GATEWAY PORTABLES & SHADE STRUCTURES

Bid Clarification 04

October 9, 2026

DSA File Number: 7-H4
DSA Application Number: 01-122796

3 MULCH
NOT TO SCALE

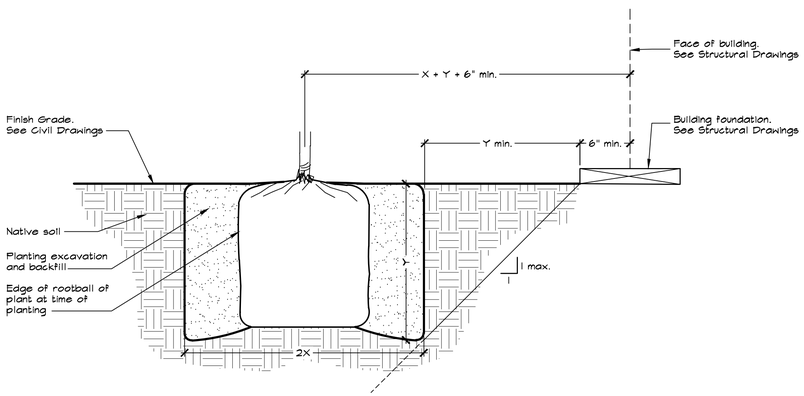
Question: Please provide the required material specification for the weed fabric noted in Note 7 on Sheet L4.1.

Answer: Mirafi 140N or equal.
